AR-3 Crossover Schematics

During its production cycle, AR modified the AR-3 crossover schematic several times. This note attempts to catalog those changes based on detailed information available in Tom Tyson's files. At some point a complete description of the AR-3 will be written [TT]; at that time this should become an appendix within that document.

B. Serial numbers C1414 – C19467:

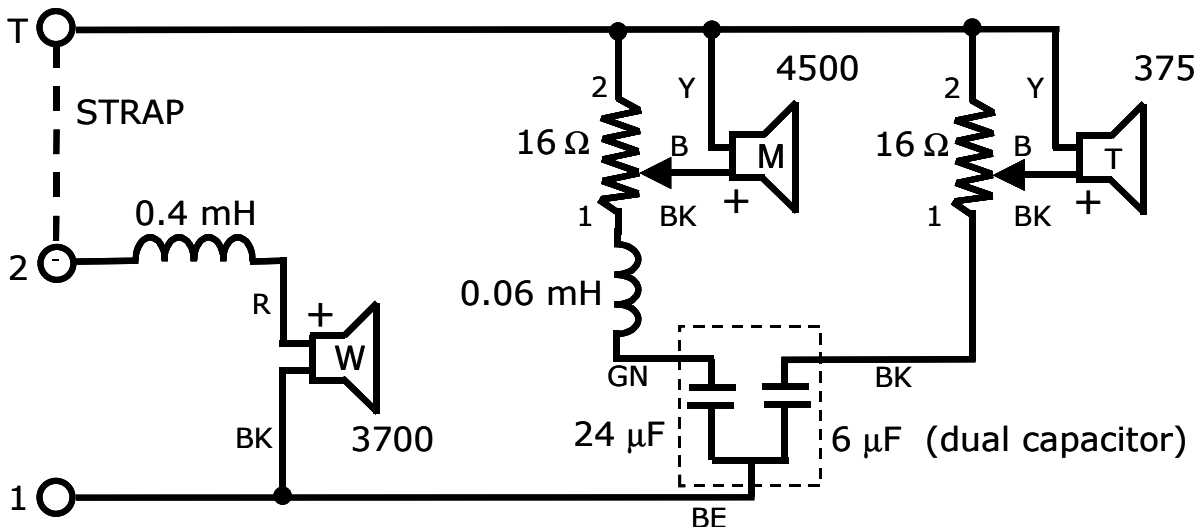
In 1960 the crossover was changed to reverse the phase of the mid-range and tweeter with respect to the woofer [1]. This was the only change made at this point in production.

C. Serial numbers C19468 – C70228:

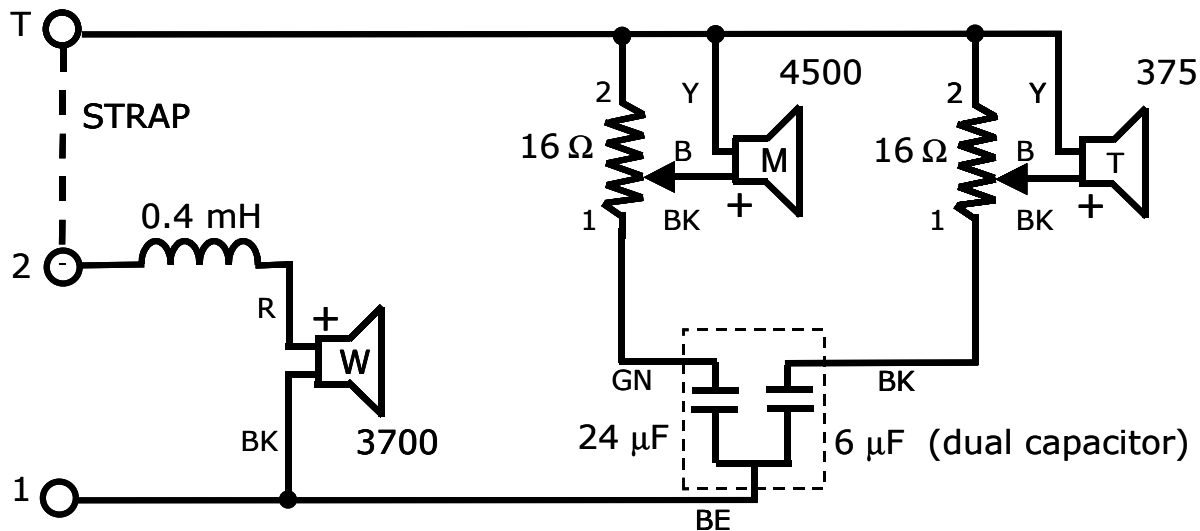
The crossover was modified on 25 Aug. 1965 by removing the 0.06-mH (51-turn) coil in the mid-range crossover.

D. Serial numbers C70229 to end of production:

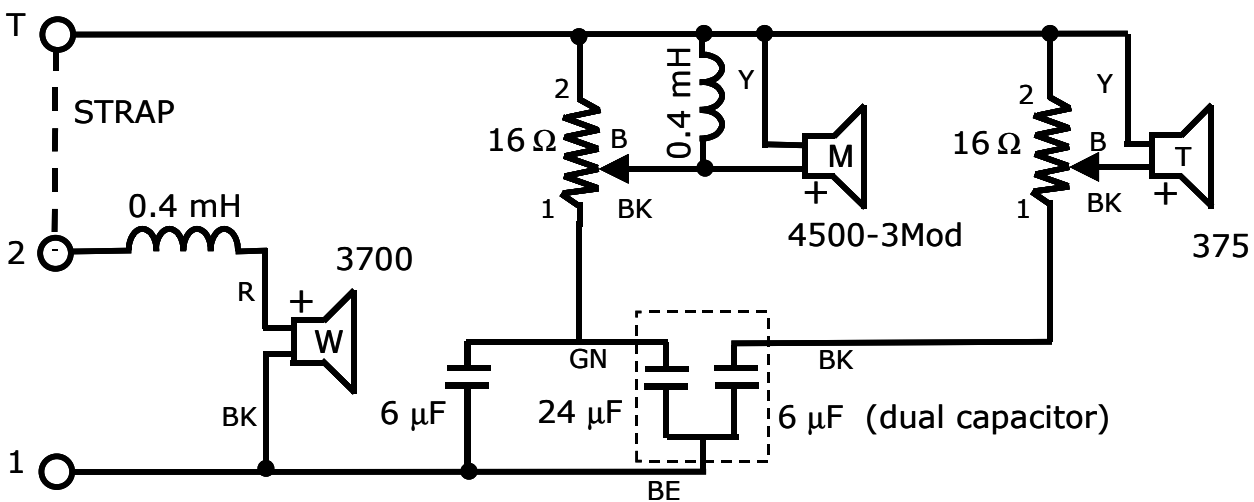
On 13 May 1970, AR ran out of the original phenolic-dome mid-range. This required the use of a version of the AR-3a mid-range identified by part number 4500-3MOD and later identified as part number 200010-AR-3 or 200019-3. (These are Fig's. A.9 and A.10, respectively, in *Restoring the AR-3a.*) This required a crossover change, as the AR-3 and AR-3a did not have the same woofer-mid-range crossover frequency. This crossover change consisted of the addition of a 6- μ F capacitor in parallel with the 24- μ F (to make a total of 30 μ F) and the addition of a 0.4-mH (143-turn) coil across the mid-range driver. These changes are illustrated below.

E. Replacing the AR-3 mid-range with a service replacement:

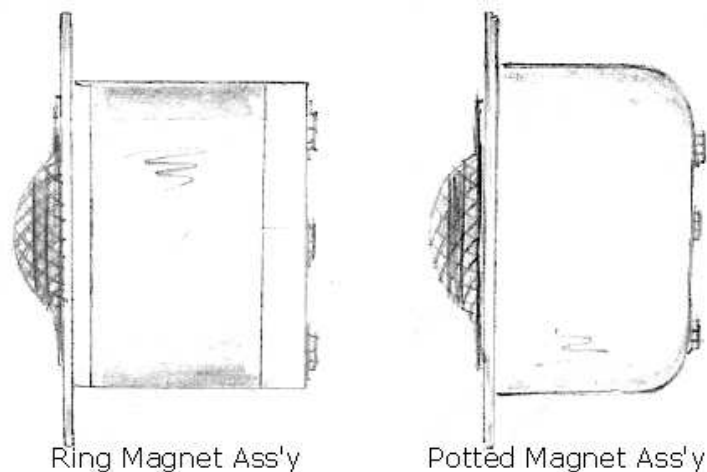
After the original mid-range supplies were exhausted, the new driver described in Section D was used for both production and service replacement. *So it is possible that an Internet-purchased speaker contains a service replacement mid-range.* Service replacement was not straightforward, as the crossover had to be changed to that shown in Section D. Thus, speakers with serial numbers of C19467 and lower needed to have their 51-turn coil removed before the parts for the new service replacement were added. Speakers with serial numbers greater than C70228 would not have needed the crossover modification, since the new style mid-range was installed when originally assembled.
